# EXHIBIT C

**BIG HORN COAL COMPANY  
10980 SOUTH JORDAN GATEWAY  
SOUTH JORDAN, UT 84095**

**RE: Objections to Proposed Brook Mine Permit Application, Sheridan County,  
Wyoming**

**BHCC Objection No. 4 Attachment 1**

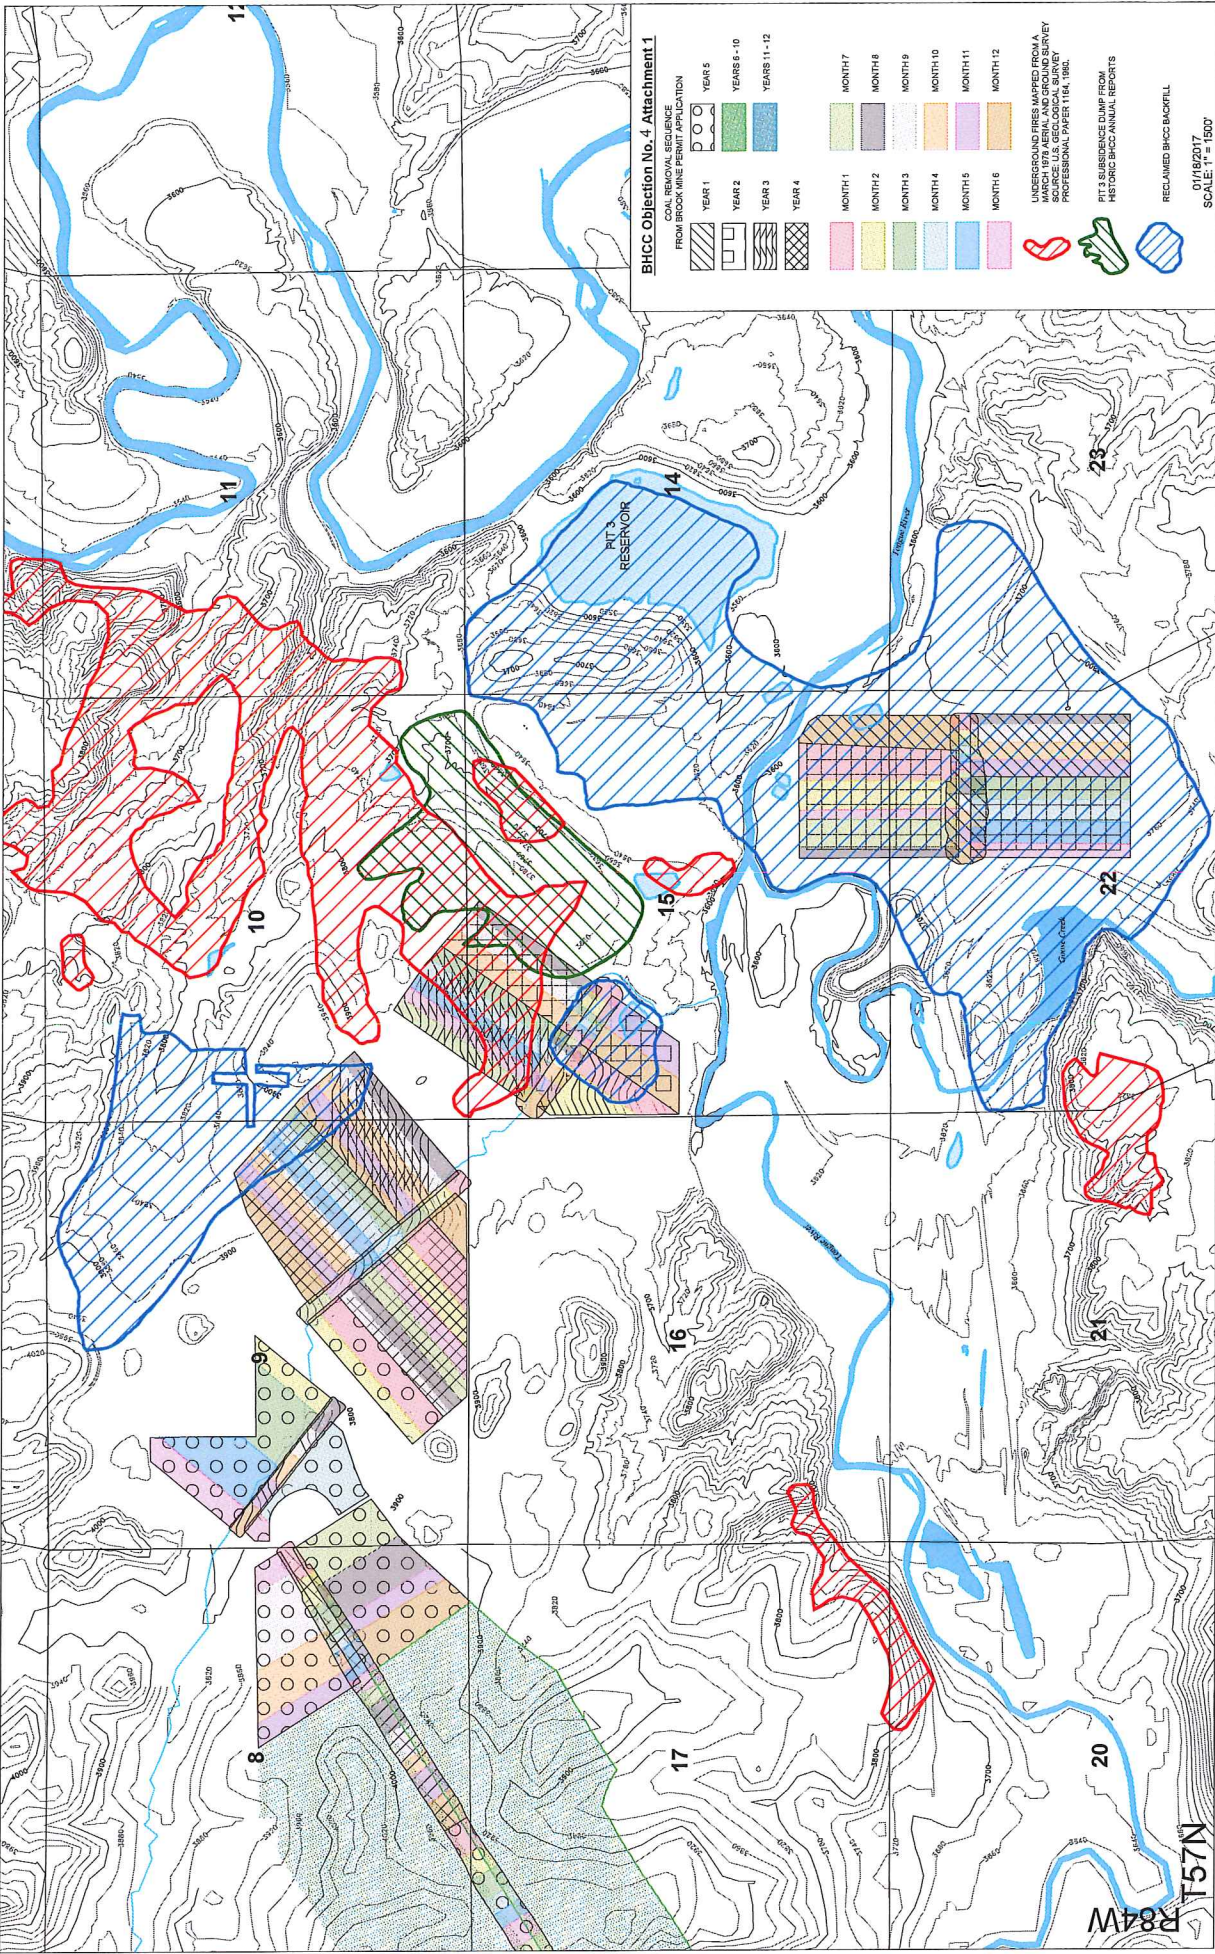
Attachment 1 provided with this Objection No. 4 is a drawing showing the approximate extent of underground coal mine fires in the area of proposed highwall mining in Sections 10 and 15, T57N, R84W, as reported by the U.S. Geological Survey in 1980. The fires in this particular area originated with mining of the Monarch coal. This and other nearby historic underground mines have long been known to exhibit numerous subsidence features and underground coal mine fires, and in the late 1980s BHCC received approval from the WDEQ/LQD to permanently place nearly 10 million bank cubic yards of overburden over the area shown on Attachment 1 in an attempt to reclaim the subsidence and control the fire. That unique reclamation feature is known as the Pit 3 Subsidence Dump in Big Horn Mine's reclamation history. The proposed highwall mining will develop mine openings in the Carney and Masters coal seams beneath the Monarch seam in areas that are known to still exhibit evidence of underground coal fires. Plumes of steam and smoke have been observed again over the general area of Sections 10 and 15 this winter of 2016-2017. These observations indicate that, in places, the perimeter of the historic subsurface coal seam fires has expanded notable distances from the referenced 1980 boundary delineation.

The subsidence control plan of Addendum MP-6 does little to guarantee the long-term protection of BHCC's surface estate especially where highwall mining panels will be driven beneath underground coal mine fires having a long history of activity. Section MP-6.2 of Addendum MP-6 provides numerical calculations for subsidence chimney heights, but there is no investigation of the potential that the historic mine fires may have compromised the structural integrity of strata underlying the fires and overlying the coals targeted for highwall panel mining (the interburden), leaving the interburden more prone to subside than normal. BHCC is particularly concerned and objects to highwall mining beneath or adjacent to pre-existing underground mine fires because of the potential for oxygen and water to be transmitted from the highwall mining openings to "hotspots" in the seams already burning via highwall trenches or via fractured or subsided interburden above the panel openings. BHCC strongly disagrees with the legitimacy of the plan stated in Section MP-6.4 of Addendum MP-6 which states "Backfilling will also be performed if it is determined that the introduction of water and oxygen could contribute to spontaneous ignition of the remaining coal not extracted from the highwall mining operations". BHCC

contends it to be common knowledge in the mining industry that oxygen and water are key catalysts in causing spontaneous combustion in coal, whether the coal be in mine openings or in stockpiles. BHCC also believes that the introduction of additional water and air to a coal seam already on fire is especially problematic.
